Subject: Braidwood Station Units 1 and 2  
Additional FSAR Information  
NRC Docket Nos. 50-456/457

The Attachment to this letter provides our response to Questions 241.1, 241.2, 241.7, and a revision to 241.6-3. Our FSAR will be amended to include the information contained in the Attachment to this letter as appropriate. Additionally, in supplement to Question 361.5 Part (a), photographs with identifiable sections of the excavations of the main power block have been sent directly to Ms. Janice A. Stevens as listed in the Attachment.

BRAIDWOOD-FSAR

FIGURE Q241.2-1  
GRAIN SIZE ENVELOPE, SAND  
BACKFILL, ESWP WITHIN ESCP

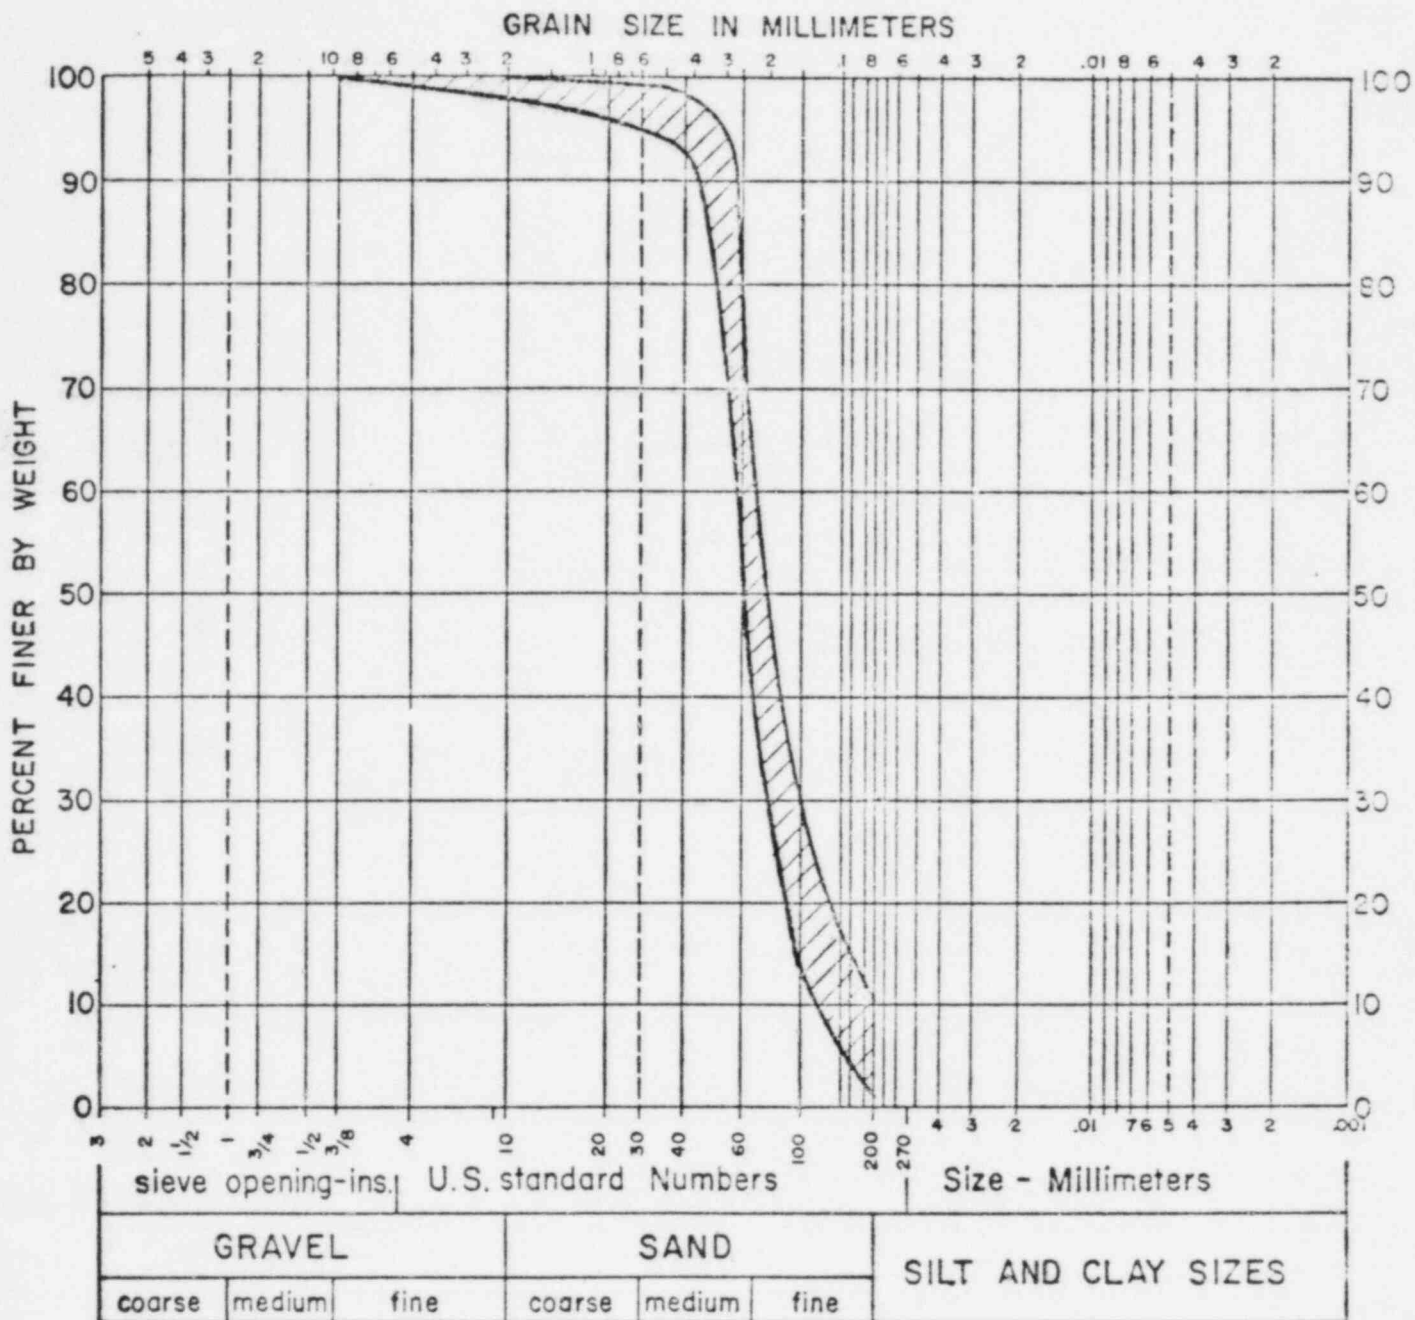
"Provide information on the gradation, method of compaction, placement density, and moisture content specified for the granular backfill used beneath and surrounding all Category I structures and buried pipes. Furnish plots presenting results of the quality control field tests performed to verify that the actual construction is in compliance with the specifications."

Category I granular backfill for the main plant and essential service cooling water pipelines has been discussed in detail in Subsections 2.5.4.5.2.2 and 2.5.4.5.4.2, respectively. Project specifications specified that the backfill material be approved material from previous excavations or borrow areas onsite. The sand backfill used was approved. Figures 2.5-261 and 2.5-262 give an envelope of 58 grain size curves for the granular backfill used in the main plant area and three grain size curves for the granular backfill used in the essential service water pipeline trench also in the main plant area. Figure Q241.2-1 gives an envelope of 12 grain size curves for essential service water pipeline backfill within the essential service water cooling pond.

Specifications required the Category I granular backfill to be compacted by vibratory compactors to minimum 85% Relative Density. A discussion of the results of 273 inplace density tests (ASTM D 1556) for the main plant area is presented in Subsection 2.5.4.5.2.2. These test results indicate compliance with project specifications. Results of the inplace density tests for compacted granular fill placed outside the main plant area of the buried pipeline also indicated compliance with project specifications. The frequency of field density and laboratory testing exceeded the minimum specified. Specifications required the following material testing and frequency.

FIGURE Q241.7-1  
 CRITICAL SECTION FOR  
 STATIC ESCP SLOPE  
 STABILITY ANALYSIS

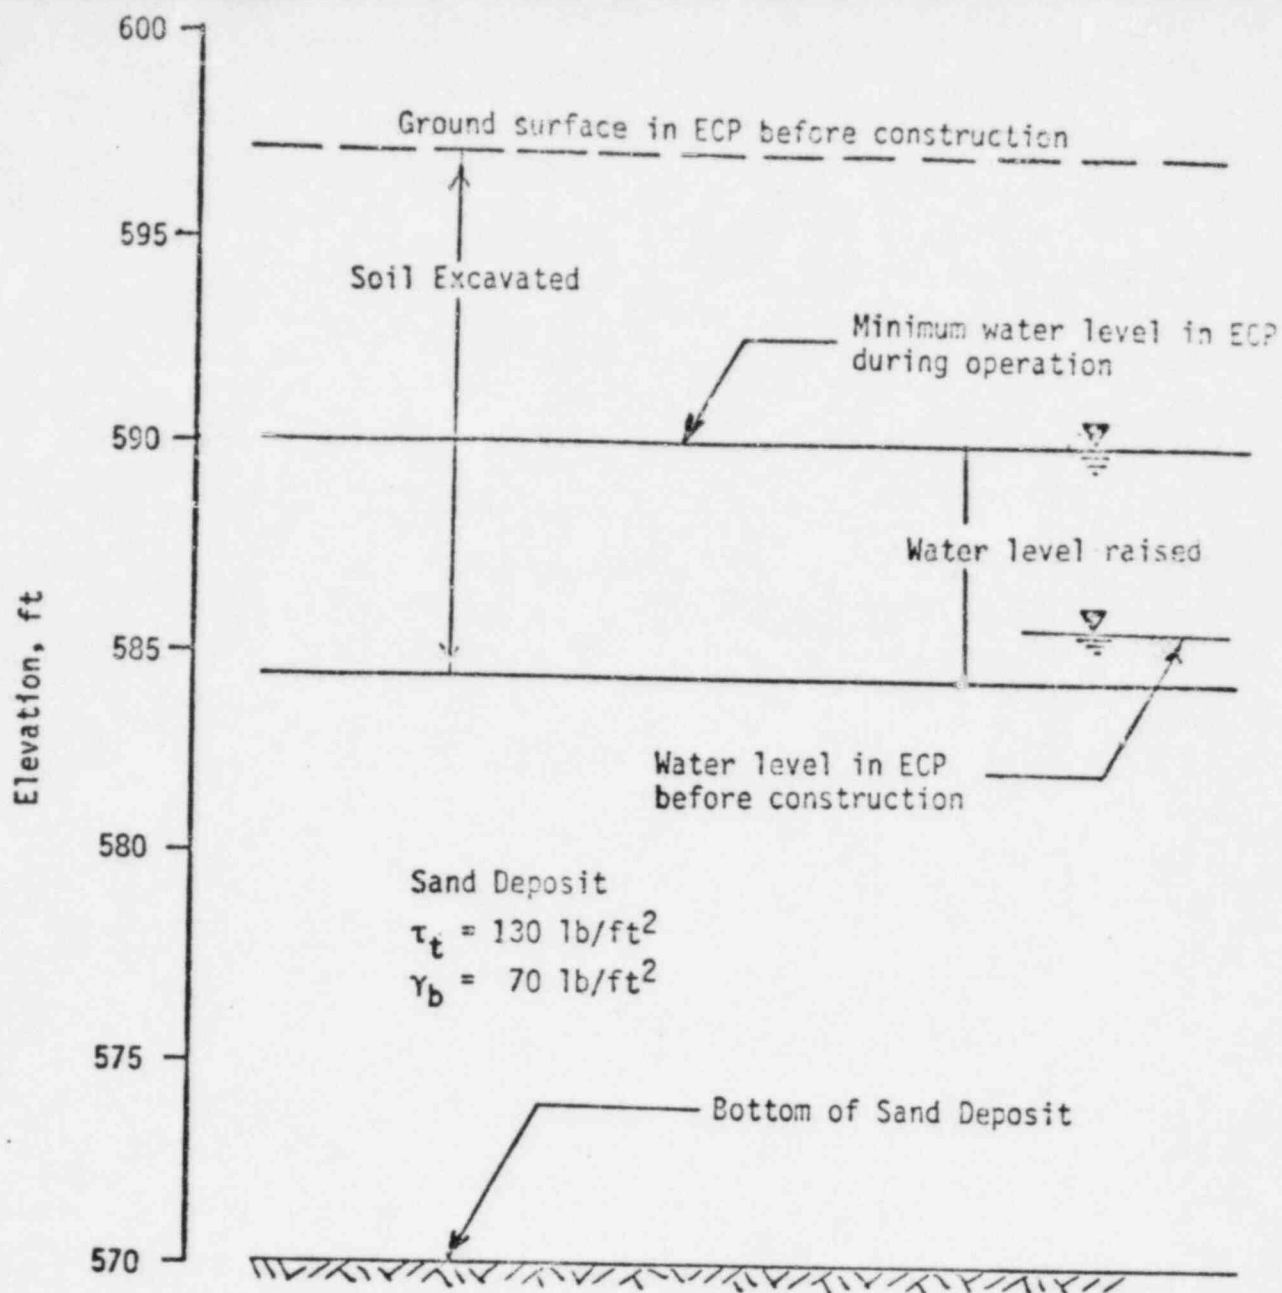
- "1. Present a figure showing the critical section of the ESCP slope analyzed for static stability. Show the critical failure surface and the corresponding factor of safety against failure.

1. The critical section of the ESCP slope analyzed for static stability is given in Figure Q241.7-1. The analysis is for end of construction condition with a minimum factor of safety of 5.9 as discussed in Subsection 2.5.6.5.1.2.
2. The seismic coefficient used in evaluating the dynamic stability of the ESCP slope by pseudostatic method of analysis was 0.2g. The minimum factor of safety is 1.3 as discussed in Subsection 2.5.6.5.1.2. The ESCP slope has also been analyzed with a seismic coefficient of 0.26g and the minimum factor of safety is 1.1.
3. The dynamic stability of the ESCP slope by finite element methods was not performed because the pseudostatic analysis used yields conservative results and a greater minimum

#### FIGURE Q 241.7-2

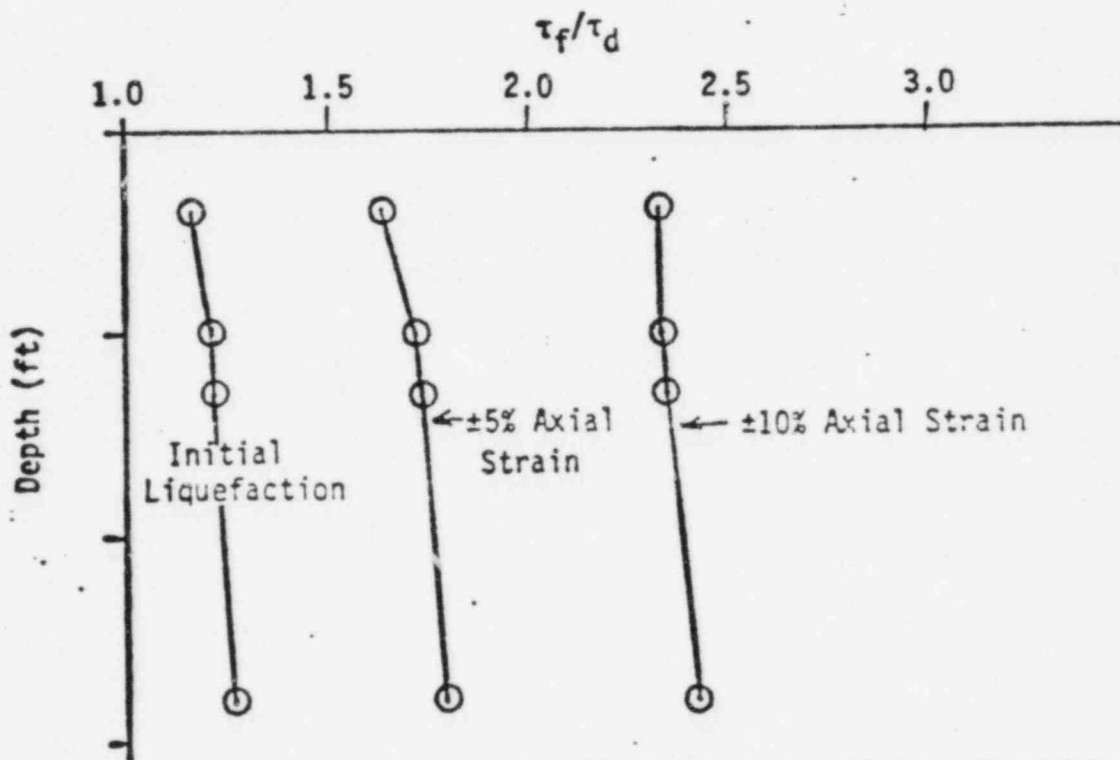
- "5. Discuss the static and dynamic stability of the Category I sheet pile wall adjoining the Lake Screen house. Present a detailed cross section and plan of the critical section analyzed for stability.

1. "Ground Motions and Soil Liquefaction During Earthquakes," Seed & Idriss, Earthquake Engineering Research Institute, 1982.
5. There is no Category I sheetpile wall adjoining the lake screen house. The retaining walls adjoining the lake screen house are reinforced concrete wing walls founded on Wedron silty clay till between elevations 561 feet 9 inches and 569 feet 0 inch. The walls are designed as Category I and extend as much as 100 feet east and west of the screen house. Plans and sections of the walls are given in Figures Q241.7-2, Q241.7-3, and Q241.7-4.

BRAIDWOOD STATION  
FINAL SAFETY ANALYSIS REPORT  
FIGURE Q 241.7-3  
EVALUATION OF LIQUEFACTION  
POTENTIAL - LEVEL GROUND AT  
E1 584 FT -  $C_r$  BASED ON  $D_r$

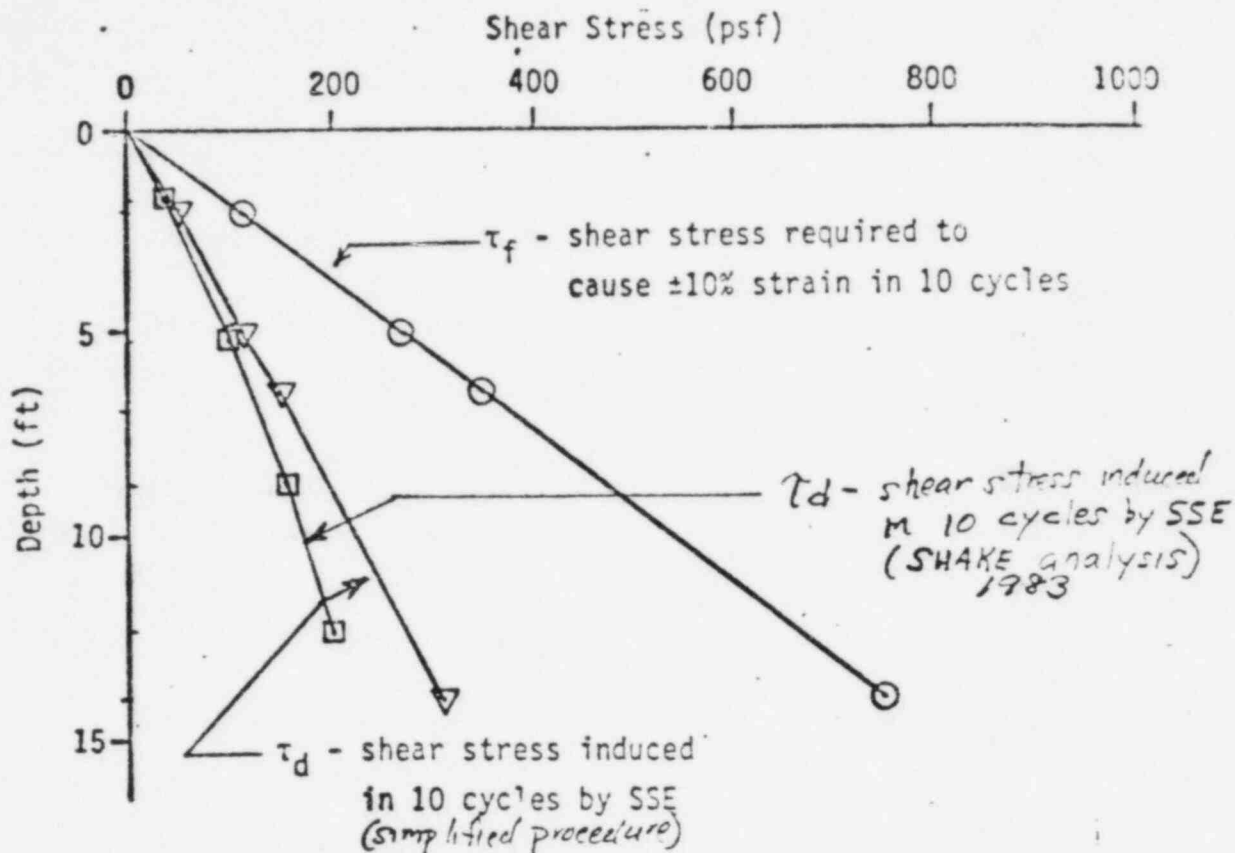
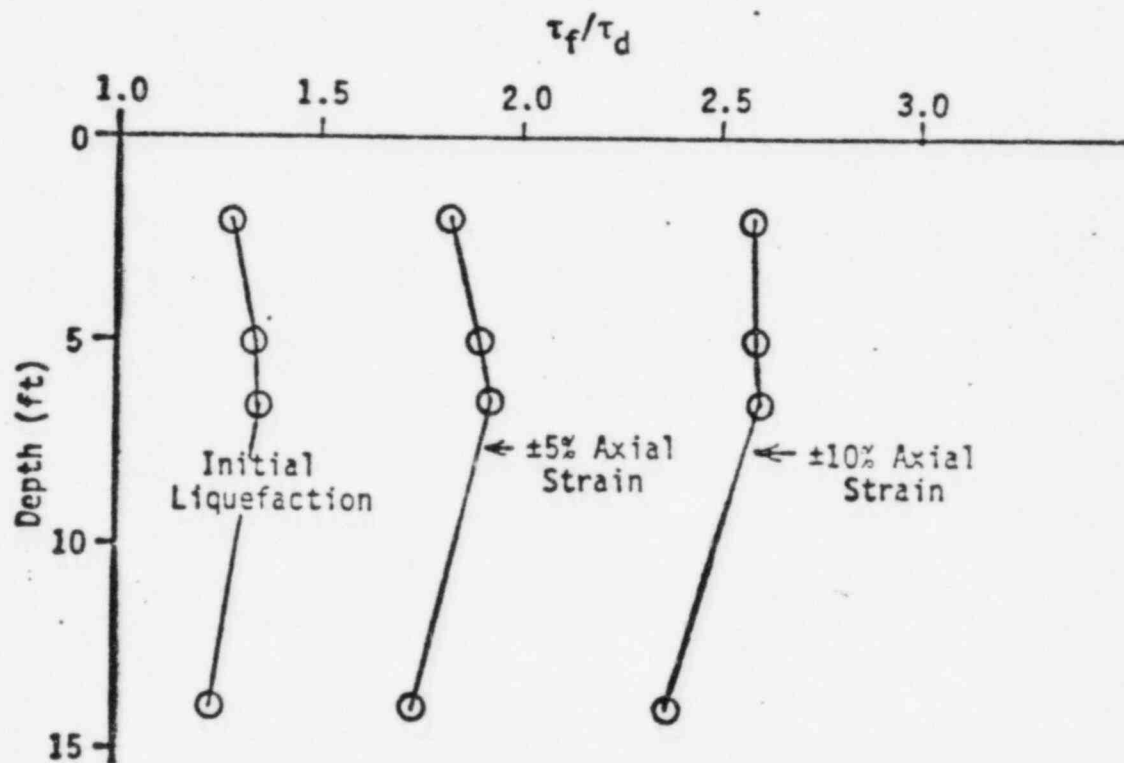
- "3. Evaluate the dynamic stability of the ESCP slope.
- "4. The liquefaction study using the SHAKE program evaluated the case with the level ground at elevation 590.0 ft. Provide the results of a similar study for the ESCP bottom, at elevation 584.0 feet.

The induced stresses, ( $\tau_d$ ), and the stresses required to cause +10% strain ( $\tau_f$ ) for level ground at elevation 590 feet are compared in Figures 2.5-116 and 2.5-117, and for level ground at elevation 584 feet in Figures Q241.7-3 and Q241.7-4. Figures Q241.7-3 and Q241.7-4 are plots of data from Table Q241.7-3 which correspond to average relative density conditions.

Based on results of the liquefaction potential evaluation presented, it is concluded there is an ample margin of safety against liquefaction of the sand deposits within the ESCP for level ground surface at both elevations 590 feet and 584 feet. Details of the analysis are discussed below.
